HISTORIC LANDMARK COMMISSION  
STAFF REPORT

**Terrace Falls Sun Deck**  
PLNHLC2014-00576  
171 East 3<sup>rd</sup> Avenue  
February 5, 2015

A request by Fernando Silva, the owner of unit 601 of the Terrace Falls Condominium, to create a sun deck on unit 601, on the west end of the building. The Terrace Falls Condominiums is located at approximately 171 East Third Avenue and is a noncontributing structure in the Avenues Historic District.

## North Elevation

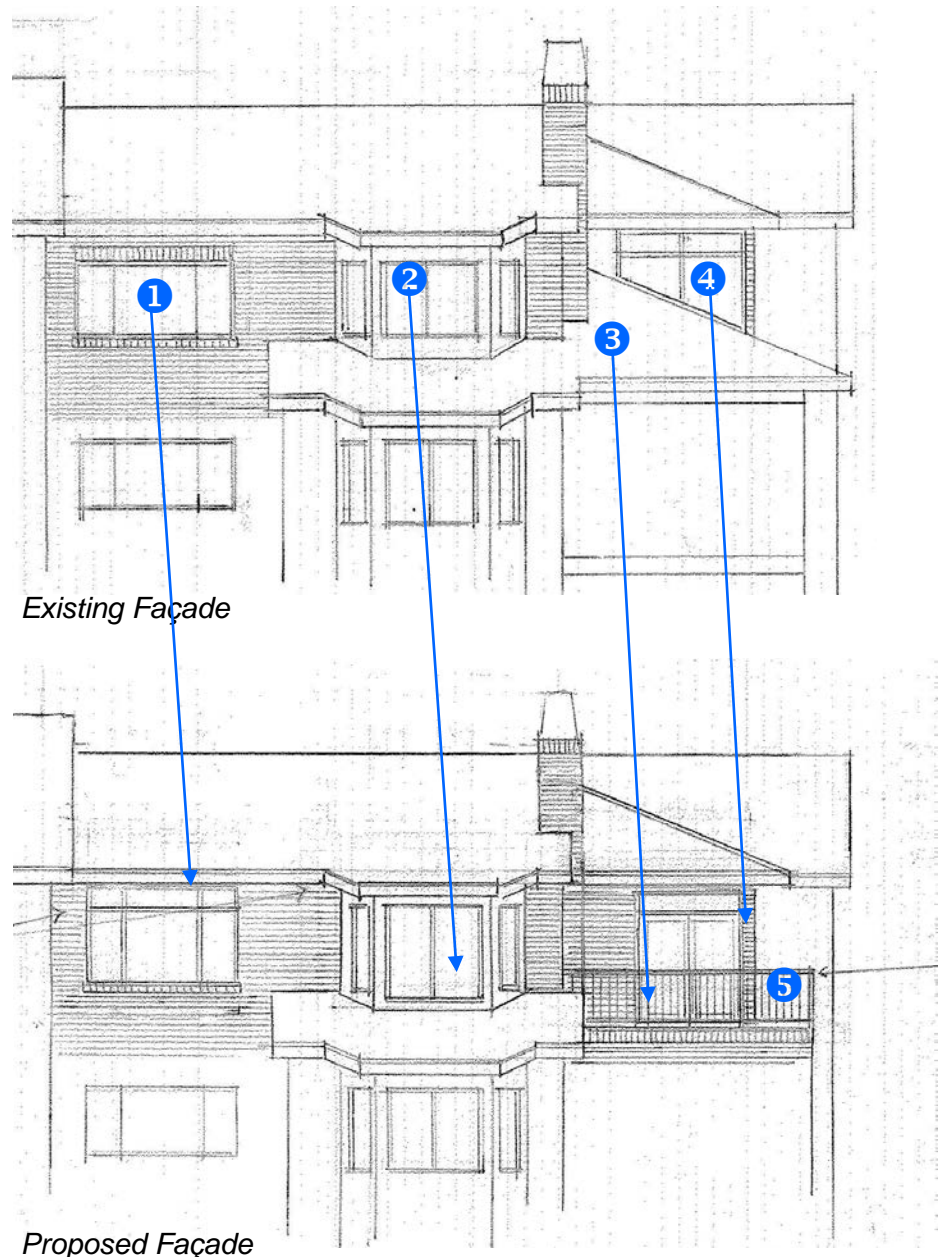
- 1 Extending the bay window on the north elevation.
- 2 Changing the sloping roof into a flat roof in order to accommodate the sun deck.
- 3 Extending the north wall laterally to create additional room on the northwest corner of the building.
- 4 Adding new railing.
- 5 Adding height to the window.

## West Elevation

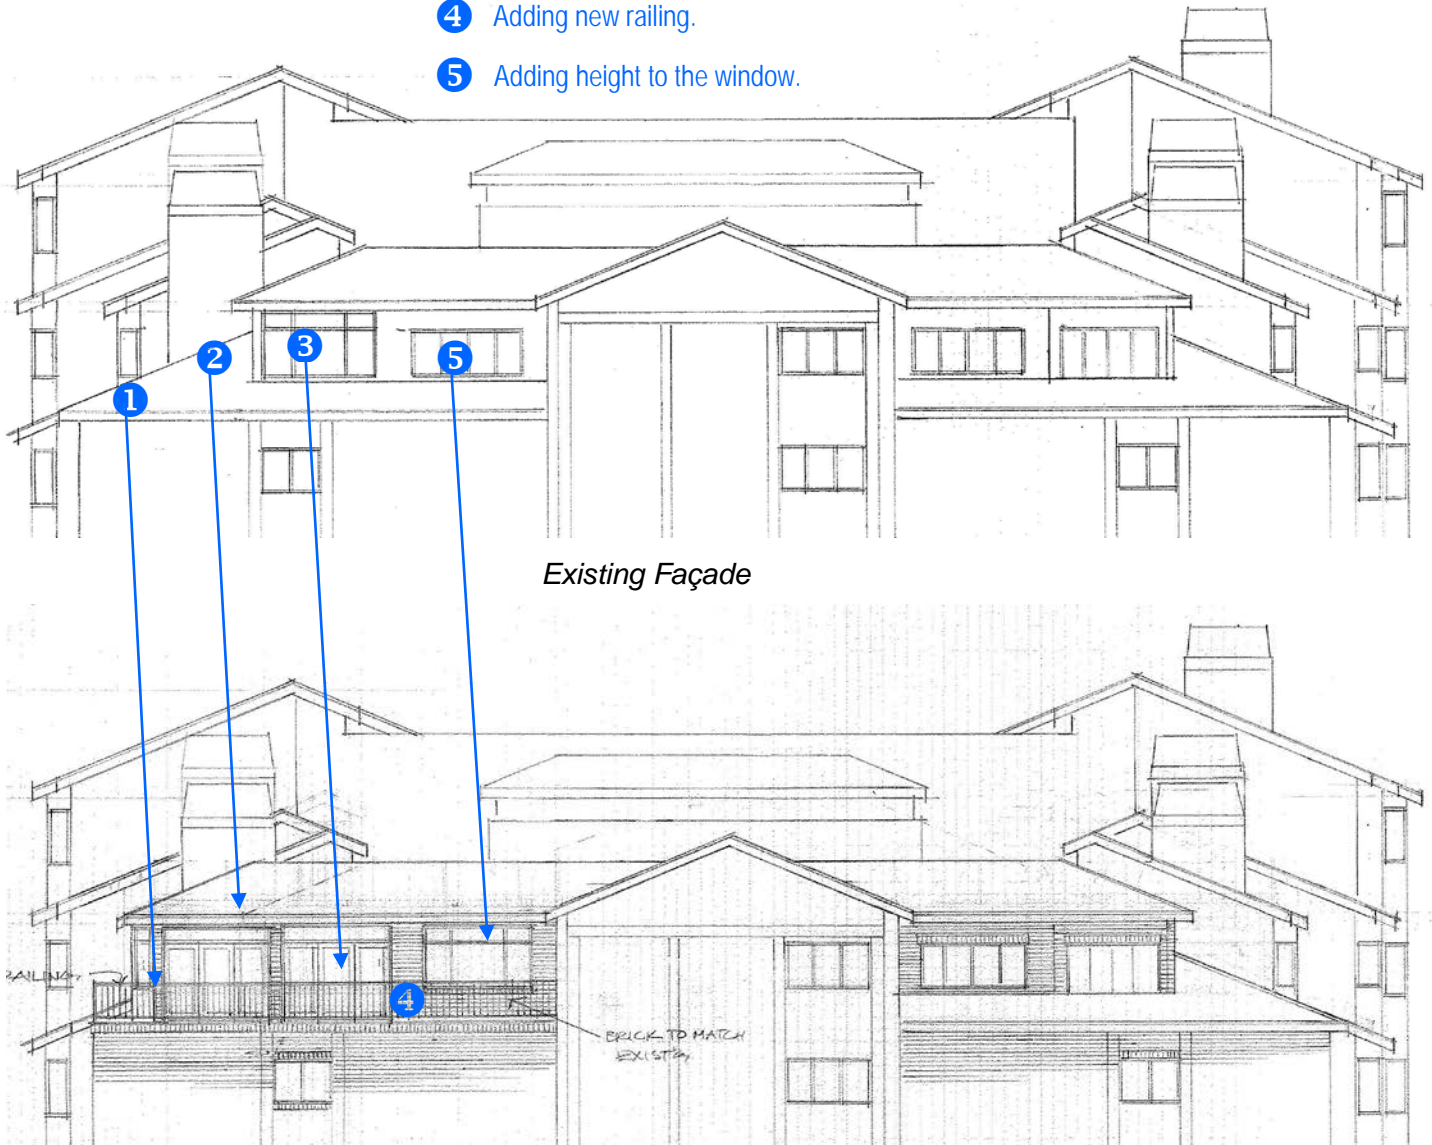
- 1 Changing the sloping roof into a flat roof in order to accommodate the sun deck.
- 2 Extending the north wall laterally to create additional room on the northwest corner of the building.
- 3 Adding new doors to the deck.
- 4 Adding new railing.
- 5 Adding height to the window.

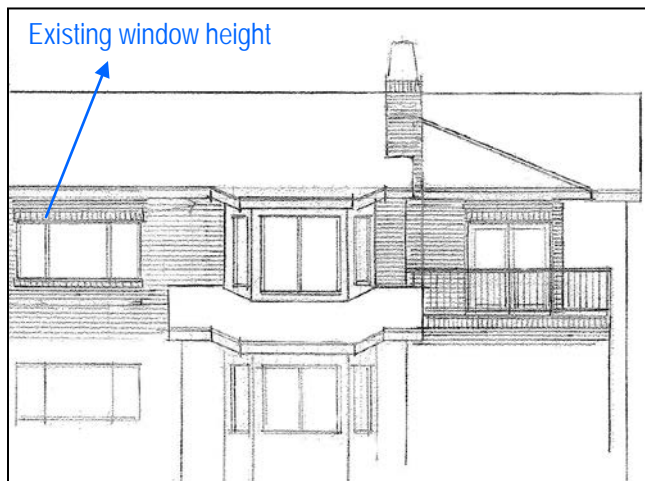
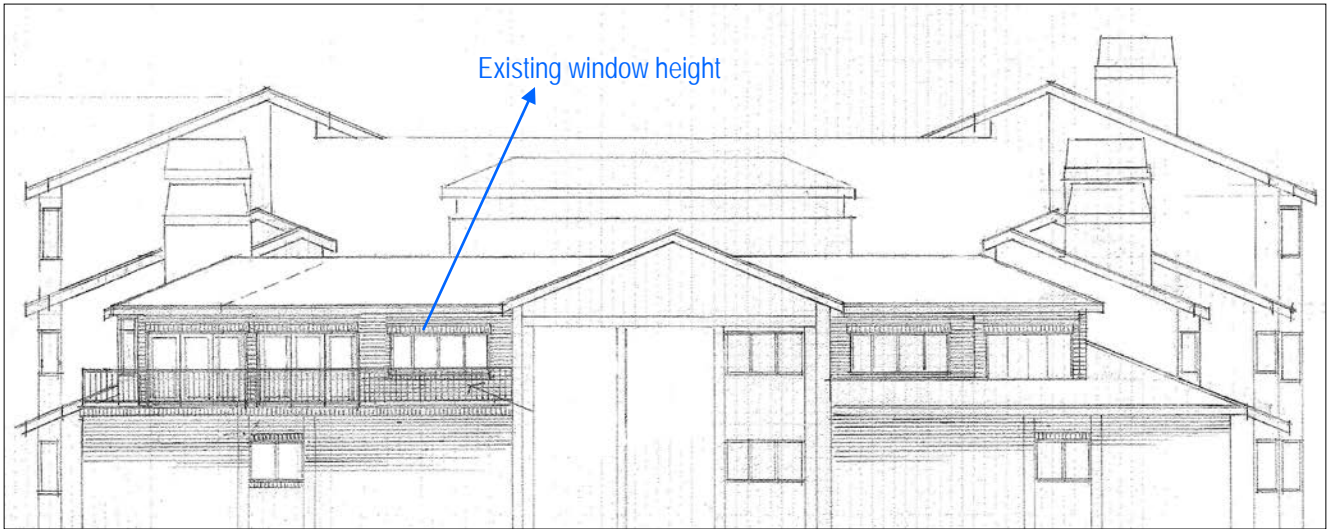
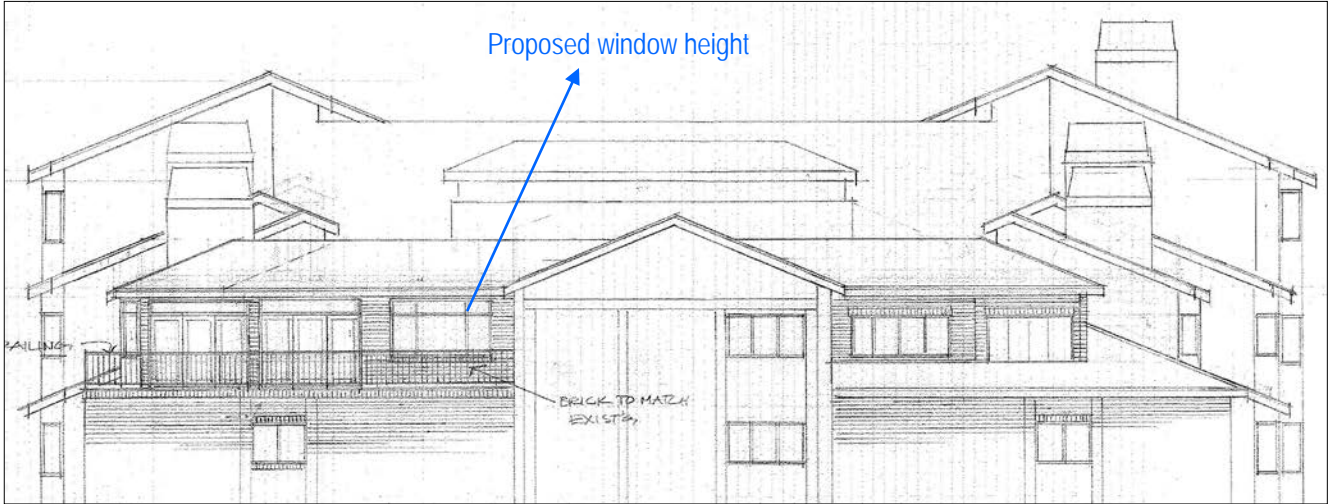
**Analysis:** The proposed changes are on the northwest corner of the structure and although they are visible, they are not on the principal façade and will not be readily visible from the street. The applicant is proposing to alter the existing windows by increasing their height. The new doors are proposed to reflect the new design of the windows. Extending the height of the bay window would not alter the character of the window pattern because it would match the existing height of the bay windows below. The materials for the additions will match the existing materials. Although it is important to ensure that new additions are to be read as such, in this case staff finds that the the differentiation occurs as the proposed changes are complimentary and sensitively designed. The proposed changes will be read as an obvious change from the original design. Thus, like for like material change is not necessary; and bricks that match the building are appropriate.

**Finding:** Staff finds that proposed materials reflect and compliment the character of the building. However, the proposed window size and detail do not reflect the characteristic window patterns of the existing architecture (see illustration below.) The proposal does not meet this standard.

1. Retaining and reflecting the existing window patterns on the existing windows and the proposed doors.
